## SB 350 Study Response to Stakeholder Questions

Since the May 24 – 25 SB 350 stakeholder meeting, the ISO has received a number of questions from stakeholders based on the data presented and released and we thought the questions and responses would be helpful for all stakeholders. The ISO intends to update this document as additional questions are received and responded to.

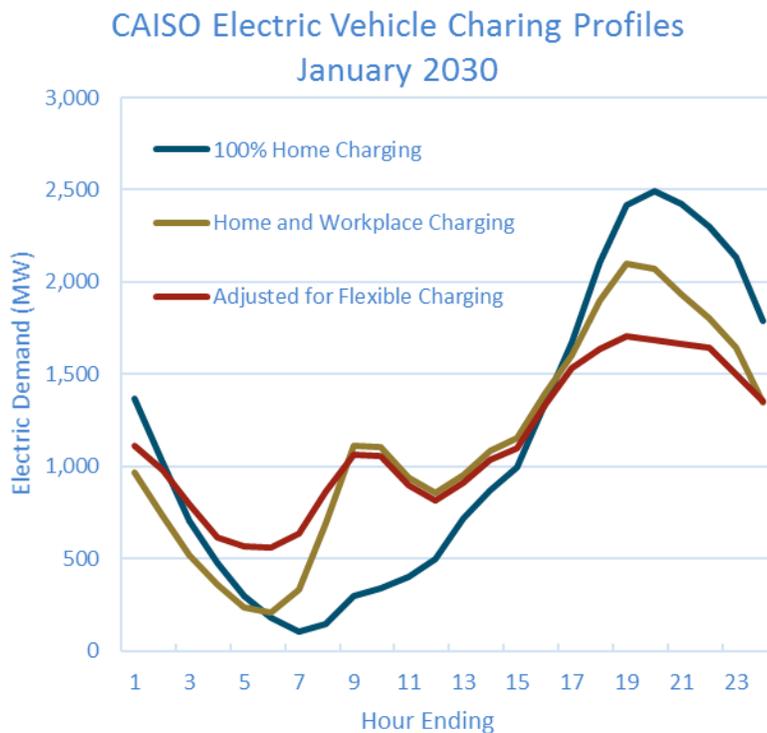
3. What is the effect of workplace charging stations modeled (e.g., quantity and timing of shifted load, or provision of ancillary services)?

E3 maintains an EV charging model that translates travel behavior from the National Household Transportation Survey into EV load shapes by weekday/weekend-day, and charging location availability, assuming the driver would charge immediately after arriving at an available charging station. These weekend/weekdays were then

aggregated and normalized into month-hour shapes. The aggregated shapes were then adjusted to take into account flexible charging. The final shapes were obtained by multiplying the normalized, adjusted shapes with forecasted annual EV demand.

The profiles below show the aggregate EV charging load in CAISO for January 2030 for different charging location and flexibility assumptions, using the 2015 IEPR estimated EV demand for 2030. Adding work-place charging shaves the evening peak by about 400 MW and introduces a new sub-peak around 9 am which is about 750 MW higher than the profile with only home charging. Adding flexible charging shaves the evening peak by another 400 MW and adds up to 400 MW of demand during the early morning hours. Other months show virtually the same charging patterns. The “Flexible Charging” pattern was used in RESOLVE.

No provision of ancillary services by EVs was assumed.
